Recall Bulletin

PRODUCT SAFETY RECALL

SUBJECT: Under Hood Fire

This bulletin is being revised to enhance the Service Procedure with additional information to assure proper sealing of the replacement valve cover gasket. Please discard all copies of bulletin 15757B.

2076766

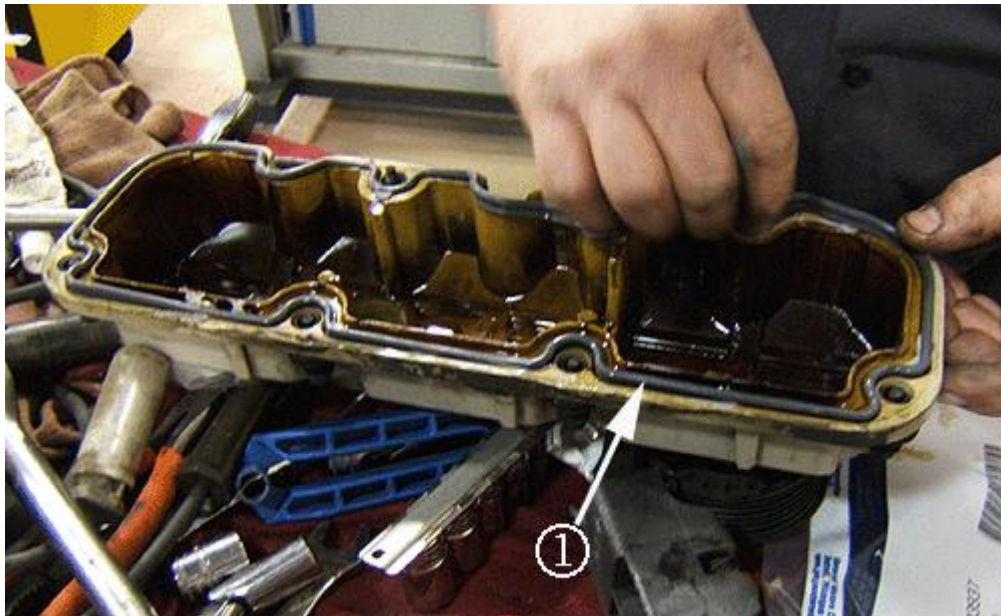
Warning: Ensure the new valve cover gasket is fully seated into the new valve cover groove. Use due care when installing the valve cover and gasket to the engine ensuring not to bump the valve cover or drag it over top of the rocker arms causing the gasket to come out of the groove. Inspect the mating surfaces of the valve cover and cylinder head to ensure the valve cover gasket is installed properly. Failure to do so may result in an oil leak and/or an engine fire.

6. Install a new left or front valve cover gasket (1) into the new valve cover and make sure that the valve cover gasket is seated properly in the valve cover groove. The old valve cover is shown for illustrative purposes only.
 - 6.1. Install the six valve cover bolts and the six grommets into the valve cover.
 - 6.2. Apply medium strength thread lock compound (blue) to the six valve cover bolt threads.
 - 6.3. Install the NEW valve cover and gasket (1) to the cylinder head.
 - 6.4. Tighten the valve cover bolts to 10 Nm (89 lb in).
 - 6.5. Verify that the valve cover gasket is properly installed (see the warning above).

2257363

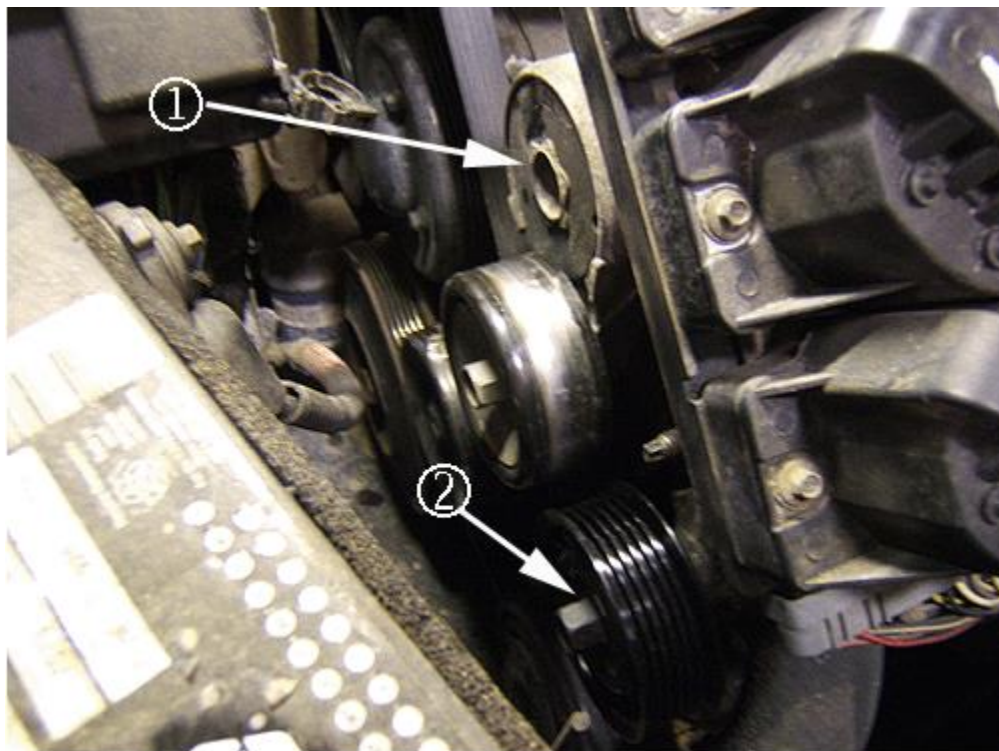
Note: Do NOT position the retainers above an exhaust runner.

- 9. Ensure that spark plug retainer (1) is connected to spark plug wire 4 and spark plug wires 1, 3, and 5. Make sure that spark plug wires 2, 4 and 6 are secured to the original retainers and under the left engine mount strut bracket (2). Verify the spark plug retainers are secured (completely latched) and they are NOT touching or over an exhaust runner.

2076766

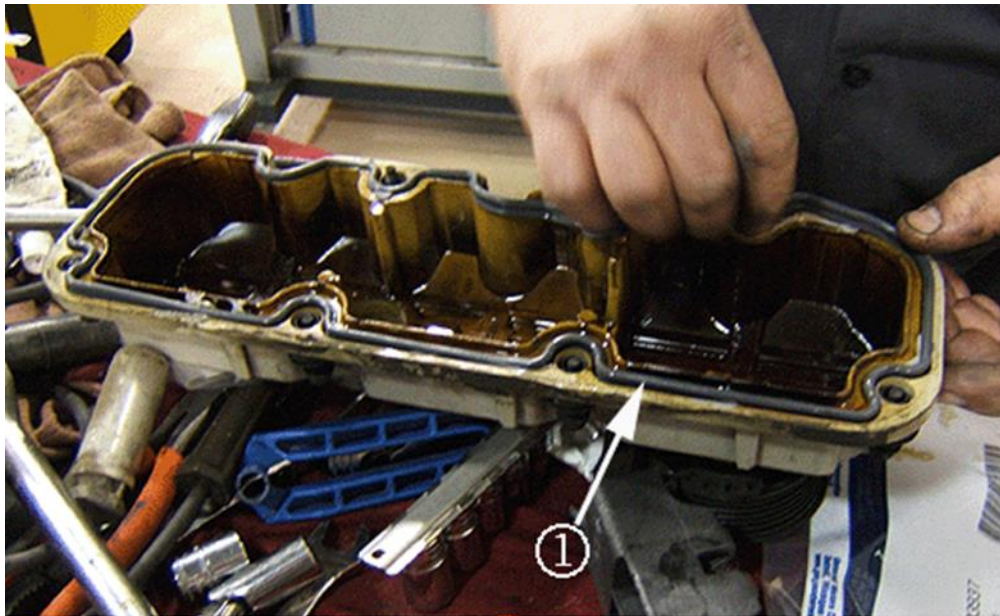
Warning: Ensure the new valve cover gasket is fully seated into the new valve cover groove. Use due care when installing the valve cover and gasket to the engine ensuring not to bump the valve cover or drag it over top of the rocker arms causing the gasket to come out of the groove. Inspect the mating surfaces of the valve cover and cylinder head to ensure the valve cover gasket is installed properly. Failure to do so may result in an oil leak and/or an engine fire.

5. Install a new left or front valve cover gasket (1) into the new valve cover and make sure that the valve cover gasket is seated properly in the valve cover groove. The old valve cover is shown for illustrative purposes only.
 - 5.1. Install the six valve cover bolts and the six grommets into the valve cover.
 - 5.2. Apply medium strength thread lock compound (blue) to the six valve cover bolt threads.
 - 5.3. Install the NEW valve cover and gasket (1) to the cylinder head.
 - 5.4. Tighten the valve cover bolts to 10 Nm (89 lb in).
 - 5.5. Verify that the valve cover gasket is properly installed (see the warning above).
6. Install the 1-3-5 spark plug wires to the ignition coils.

2257363

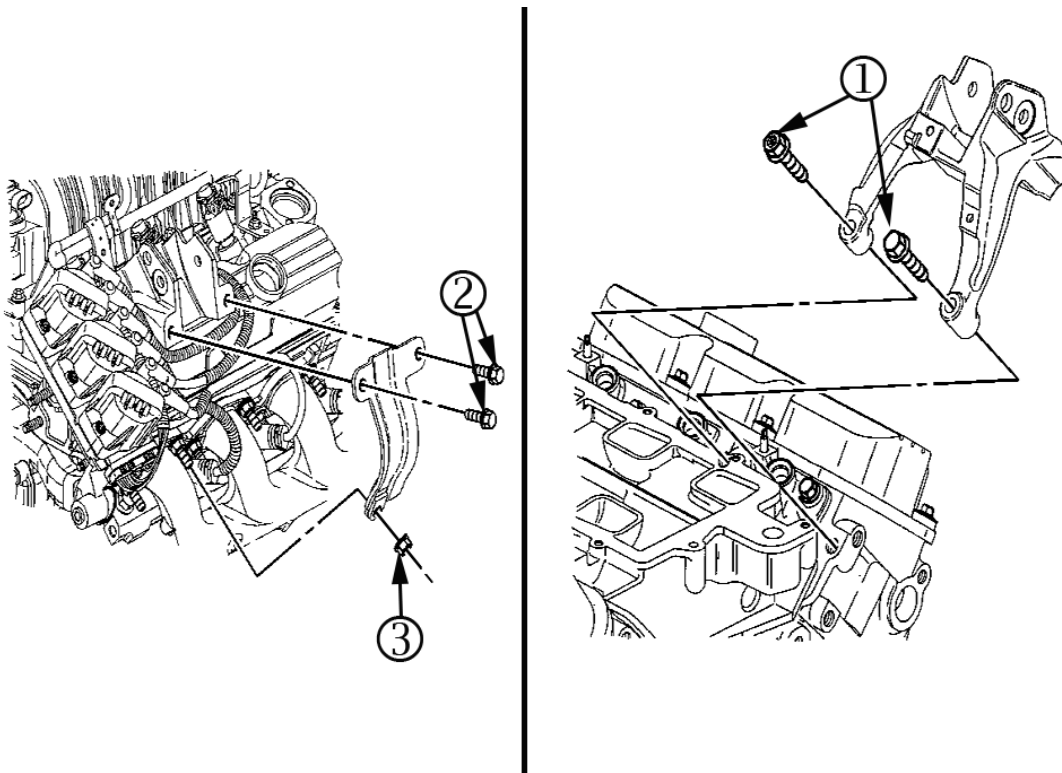
Note: Do NOT position the retainers above an exhaust runner.

7. Ensure that spark plug retainer (1) is connected to spark plug wire 4 and spark plug wires 1, 3, and 5. Make sure that spark plug wires 2, 4 and 6 are secured to the original retainers and under the left engine mount strut bracket (2). Verify the spark plug retainers are secured (completely latched) and they are NOT touching or over an exhaust runner.
